Subject: Tag Axle Lock Clamps Rework			
Field Change Program: Field Campaign	FCP Number: 477	Revision: A	Date: 02/18/2020
Coach Section: 12- Suspension	P/N: 12-04-1253		Type: Safety Recall

Ref. NHTSA Recall No.: 19V-924	Ref. Transport Canada Recall No.: N/A
--	---

1.0 Description

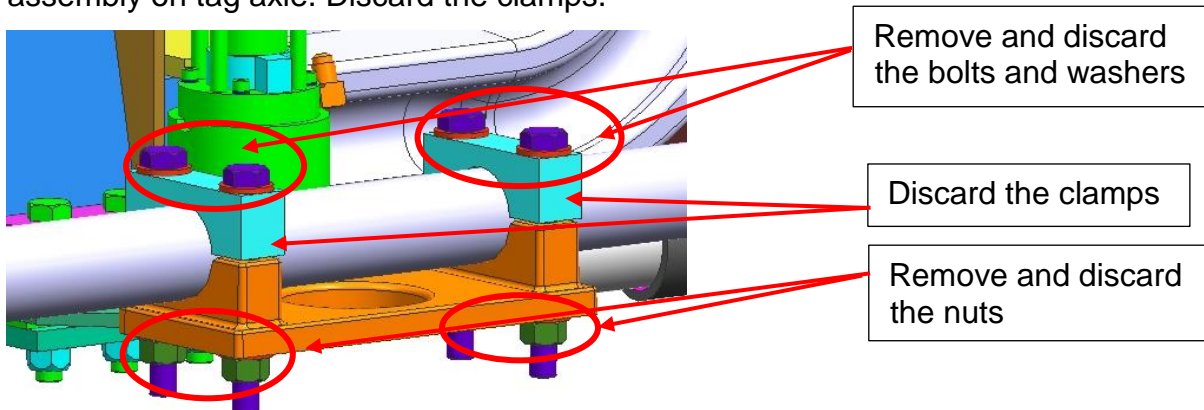
Scribe the location of the clamp and lock plate on the tie rod.

Remove and discard the 4 nuts, bolts and washers securing the clamp to the lock assembly on tag axle. Discard the clamps.

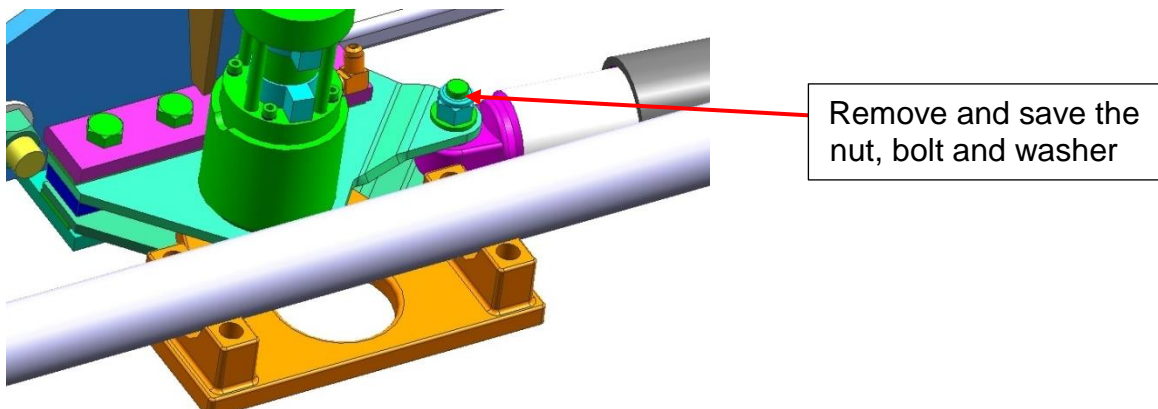
Remove and save the nut, bolt, and washer securing the lock assembly and the damper.

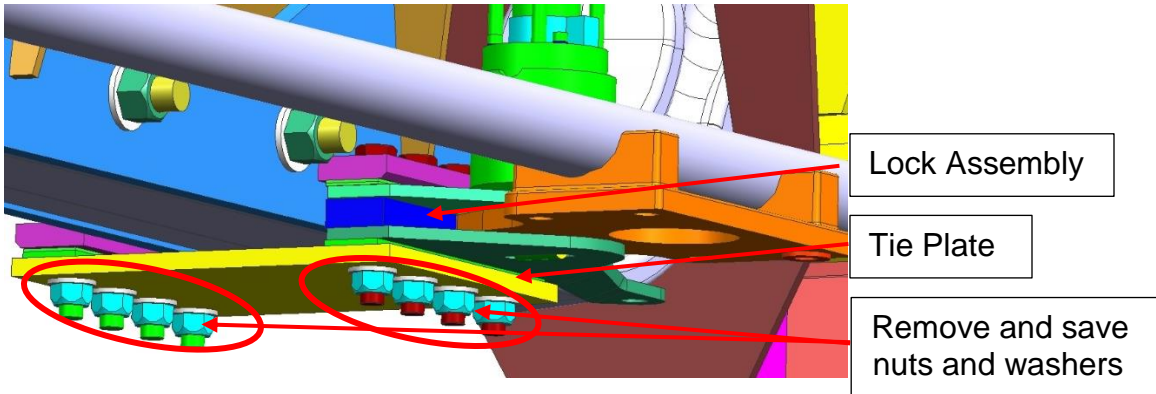
Remove and save the 8 nuts and washers securing the tie plate to the lock assembly and to the axle. Save the tie plate and shims.

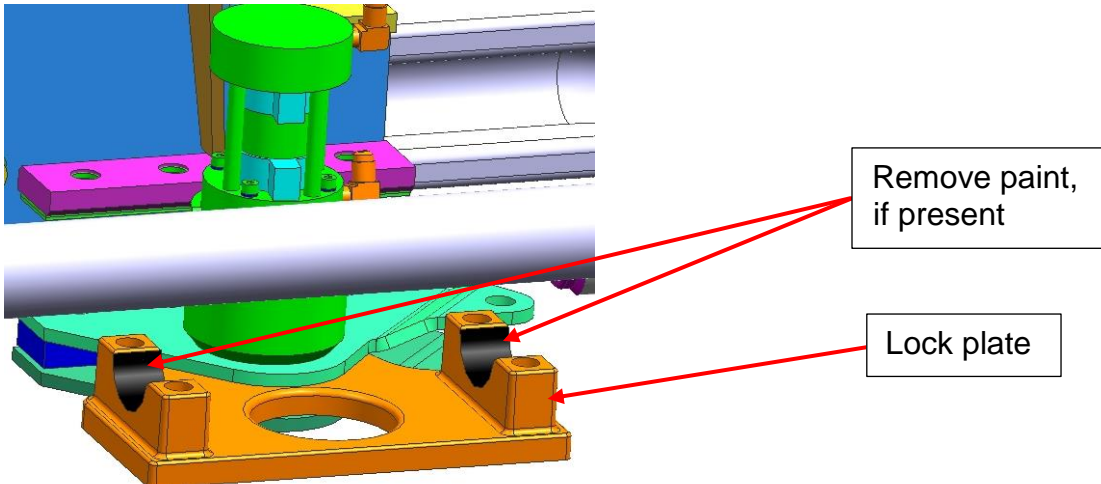
Slide the lock assembly and lock plate down and observe for paint on the lock plate at the location illustrated below. If paint is observed on the surface of the lock plate that clamps the tie rod, use an abrasive paper to remove the paint in that area.

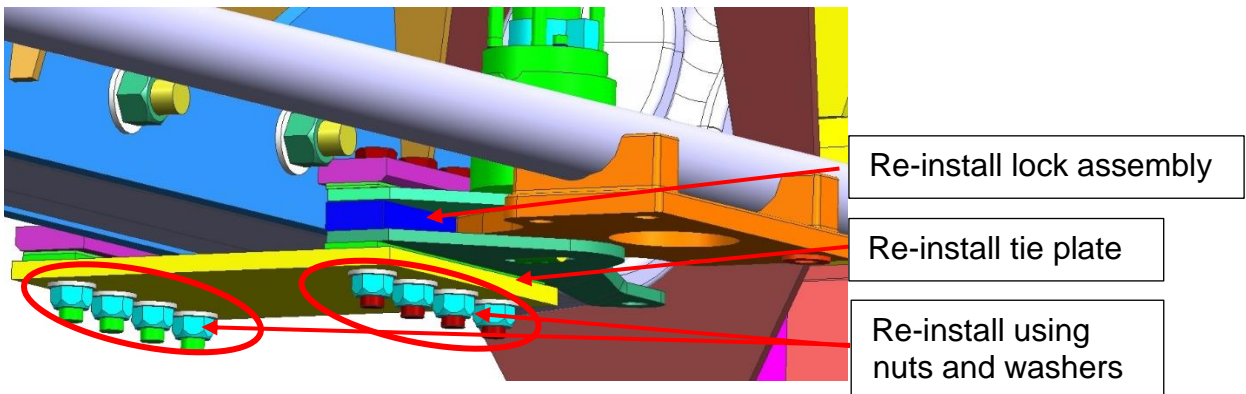
Clean the lock assembly plate with isopropyl alcohol, MCI P/N: 23-05-0005.

Re-install tie plate, lock plate, and lock assembly to the axle at the scribed location using existing nuts, bolts, washers and shims. Torque the nuts to 87 Ft-Lb.

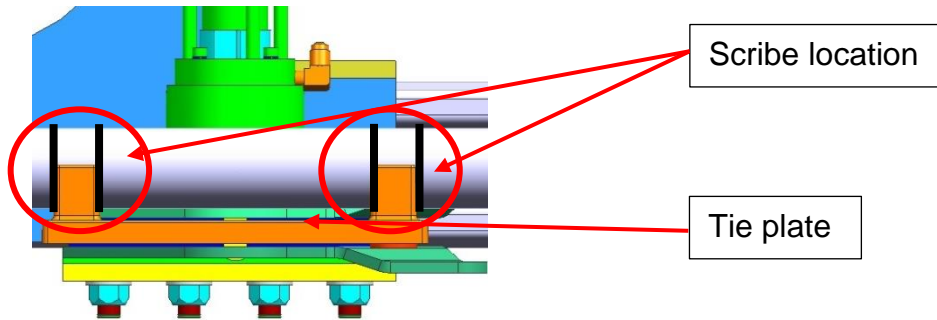
Make sure to position the lock plate at the scribed location.

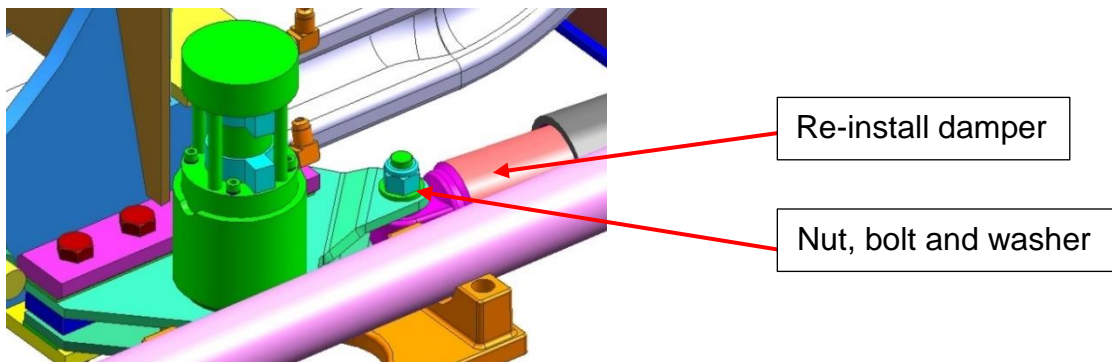
Re-install the damper to the lock assembly using existing hardware. Torque the nut to 87 Ft-Lb.

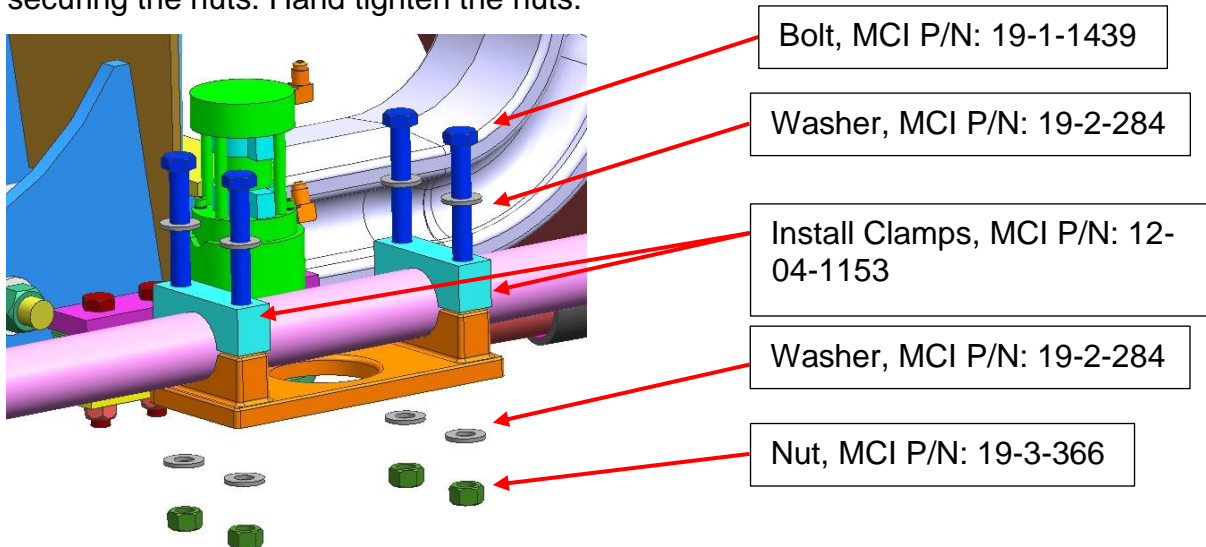
Clean the clamps, MCI P/N: 12-04-1153, with isopropyl alcohol, MCI P/N: 23-05-0005.

Install the clamps to lock assembly using nuts, MCI P/N: 19-3-366, washers, MCI P/N: 19-2-284, and bolts, 19-1-1439. Apply Loctite to the base threads of the bolts before securing the nuts. Hand tighten the nuts.

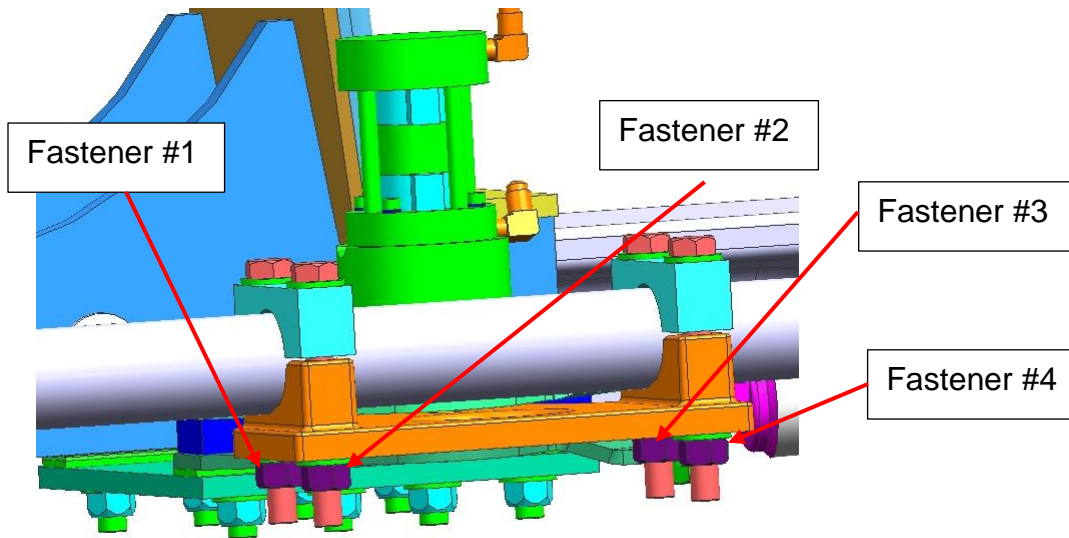
Torque fastener #1 to 15 Ft-Lb

Torque fastener #4 to 15 Ft-Lb

Torque fastener #2 to 15 Ft-Lb

Torque fastener #3 to 15 Ft-Lb

Repeat torquing the fasteners in the same sequence incrementing torque by 15 Ft-Lb until you reach 75 Ft-Lb.
